Inn at the Village Project

SUBSEQUENT ENVIRONMENTAL IMPACT REPORT

**FINAL
SUBSEQUENT ENVIRONMENTAL IMPACT REPORT**

2.0 RESPONSE TO COMMENTS

Preliminary Site Plan

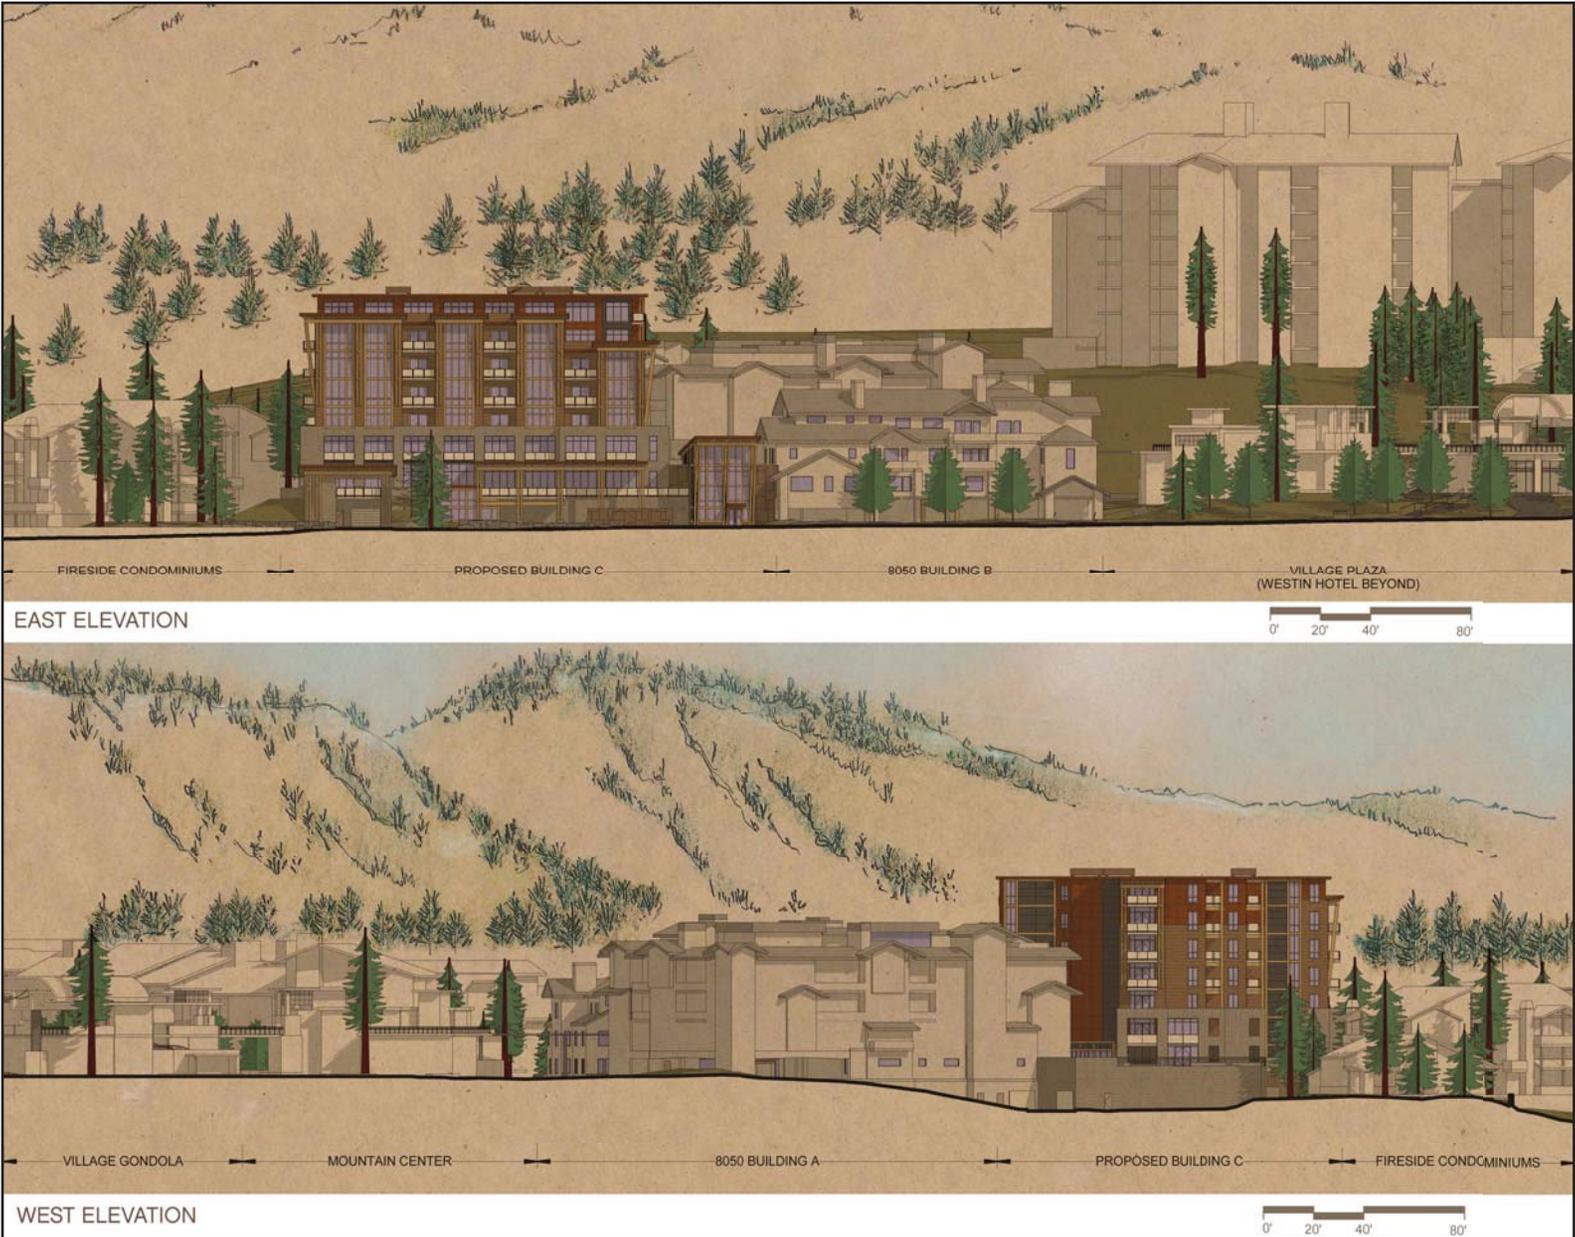
The current SEIR seeks the Towns and Commission's approval for a project to which the Project Owner does not have legal right. SEIR Section 03 Project Description, Preliminary Site Plan, Exhibit 3-3 plan notes indicate a project that is "35'...FROM FIRESIDE CONDOMINIUM STRUCTURES." As this right does not exist with the Project Owner, the project documents and SEIR should not consider them. It is our opinion that the SEIR Project Description is flawed, therefore so is the SEIR in total.

The current SEIR seeks the Town’s and Commission’s approval for a project to which the Project Owner does not have legal right. SEIR Section 03 Project Description, Preliminary Site Plan, Exhibit 3-3 plan notes indicate a project that is “35’...FROM FIRESIDE CONDOMINIUM STRUCTURES”. As this right does not exist with the Project Owner, the project documents and SEIR should not consider them. It is my opinion that the SEIR Project Description is flawed, therefore so is the SEIR in total.

- 6-1 This comment is regarding a settlement agreement between the Applicant and the Fireside Condominium Owners Association. The comment addresses the height and the location of the proposed project, and contends that the project as proposed would violate the settlement agreement. The Town is not a party to that agreement and does not have any obligation or authority to enforce it. The Town is required to evaluate the proposed project on its own merits and based on whether it complies with the Town's zoning code and development standards. Additionally, the settlement agreement does not prohibit the project from obtaining development approvals. The Applicant is aware of its obligations under the agreement.

Attachment B
Building Diagrams

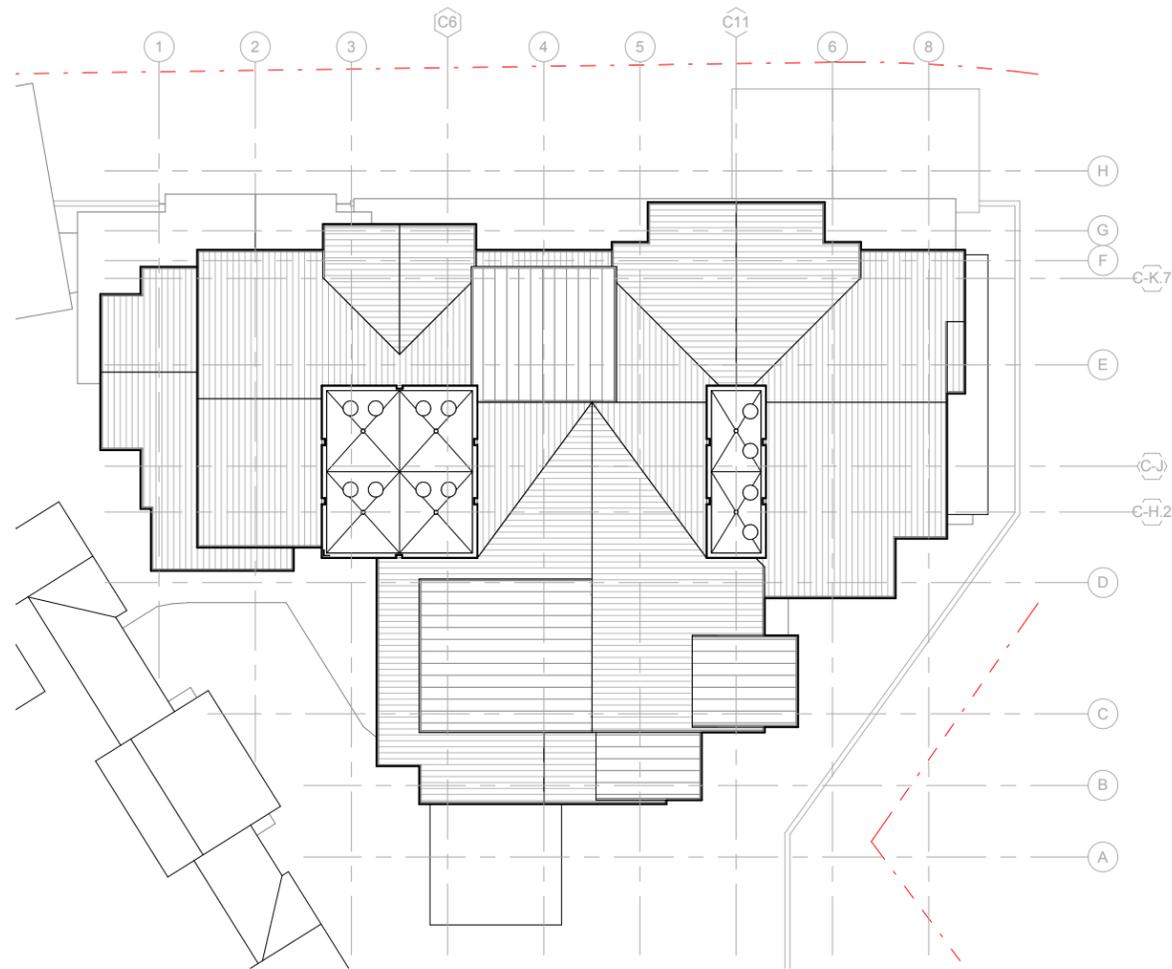
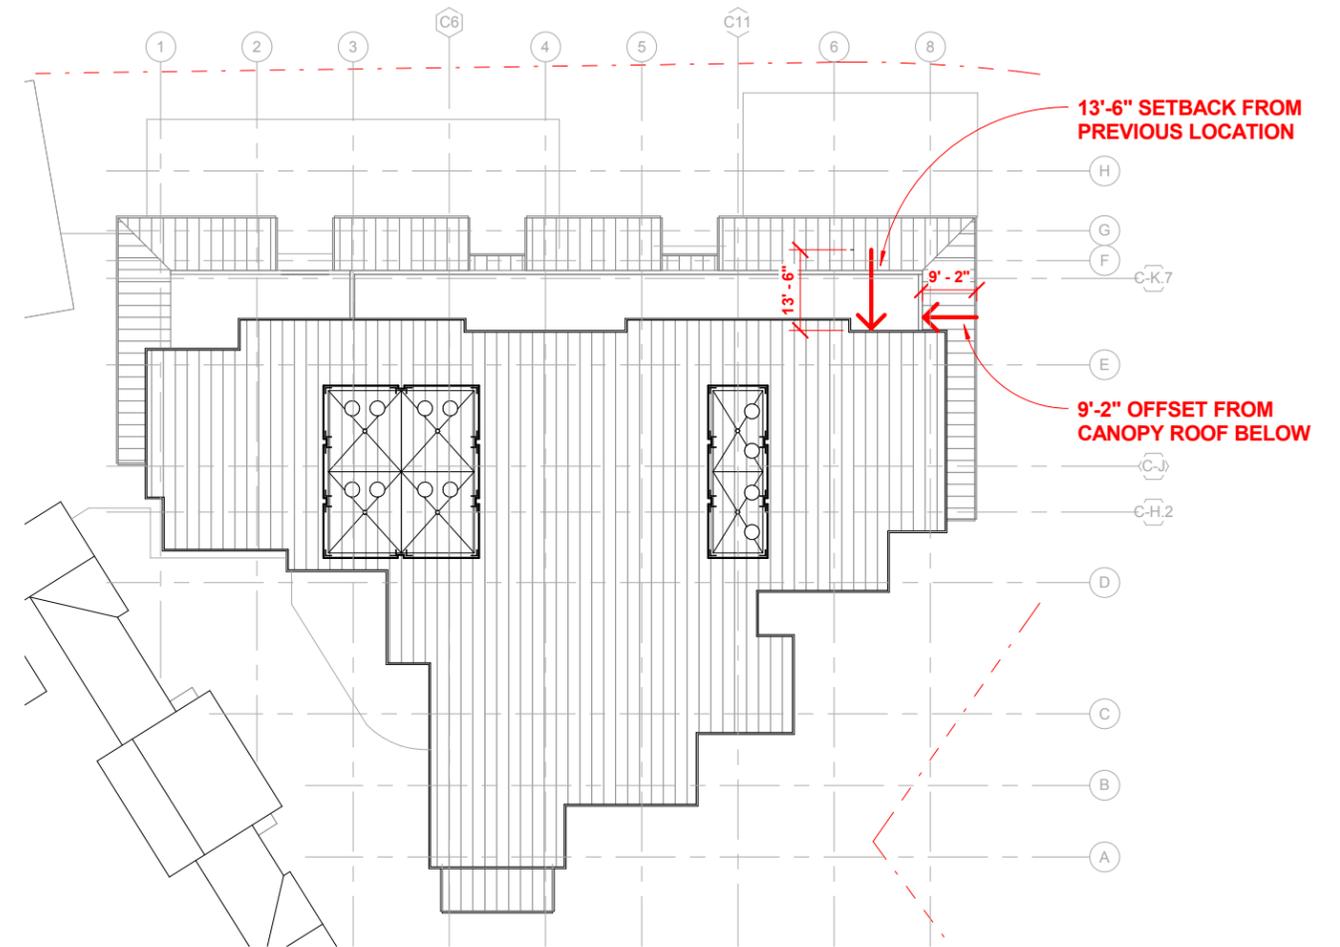
10-6 The Commenter notes a potential concern that was also voiced by the Advisory Design Panel over “larger architectural expression at the southwest corner,” which may appear to be a “looming” component of the building. The Commenter has requested that the Applicant consider stepping height down at this corner; “turn corner” in a different way.’ Attachment B, *Building Diagrams*, of this Response, includes diagrams that illustrate this portion of the building and the desire to turn the corner in a successful manner. This holistic strategy breaks up and steps back the façade in this area such that the scale feels appropriate. To reiterate this approach, the following has been used to reduce the building’s overall mass at this corner:

- The overall building height has been reduced from the original 93’-9” down to 80’-0”. Since this change, the Applicant has also added a new 13’-6” step-back from the Minaret façade in order to reduce building mass at the corner and provide a stepped appearance;
- A trellis element has been placed along the corner that further breaks down scale and enriches the building profile, reinforcing the idea of a building base, a middle, and reduced mass along the top;
- Materials and colors also vary to create distinct scaling elements: base, middle, and top;
